ECE/TRANS/WP.29/2009/105  
23 July 2009

**World Forum for Harmonization of Vehicle Regulations**

Proposal for Supplement 9 to Regulation No. 110  
(Specific components for CNG)

"Fig. 2: 20 MPa Filling unit Size 2 (receptacle) for M<sub>2</sub>, M<sub>3</sub>, N<sub>2</sub> and N<sub>3</sub> vehicles

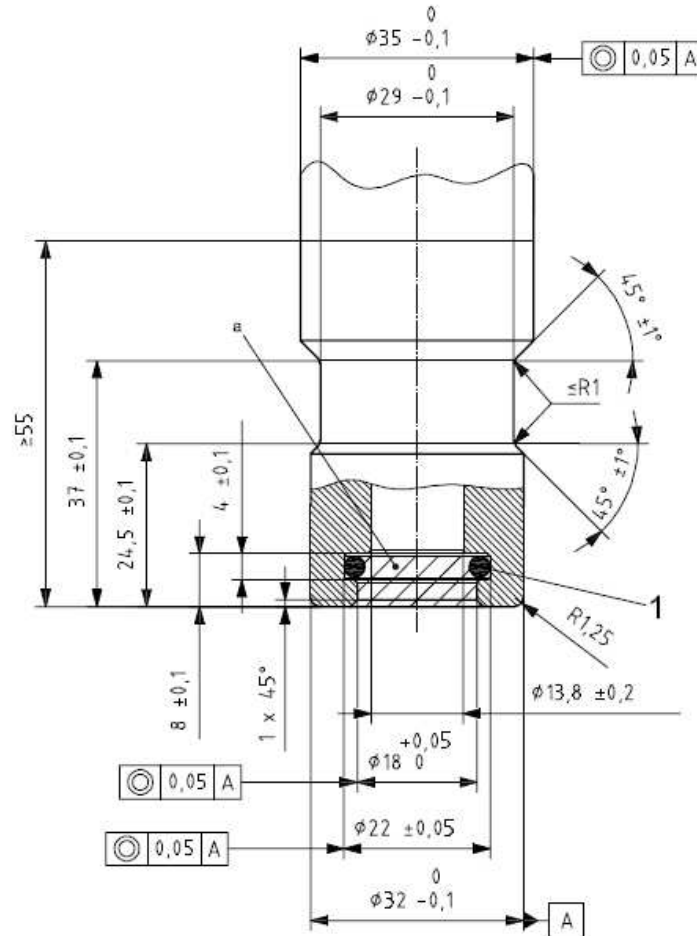
"4.2. Figure 2 shows the dimensions of the filling unit for vehicles of categories M<sub>2</sub>, M<sub>3</sub>, N<sub>2</sub> and N<sub>3</sub>. 3/"

Insert, after Figure 1, a new Figure 2, to read:

1 sealing ID =  $\varnothing 15,47 \pm 0,1$  width =  $\varnothing 3,53 \pm 0,2$

<sup>a</sup> This area shall be kept free of all components

Surface roughness < Ra 3,2  $\mu\text{m}$ .

Sealing surface finish: 0,8  $\mu\text{m}$  to 0,05  $\mu\text{m}$ .

Material hardness: 75 Rockwell B (HRB 75) minimum.
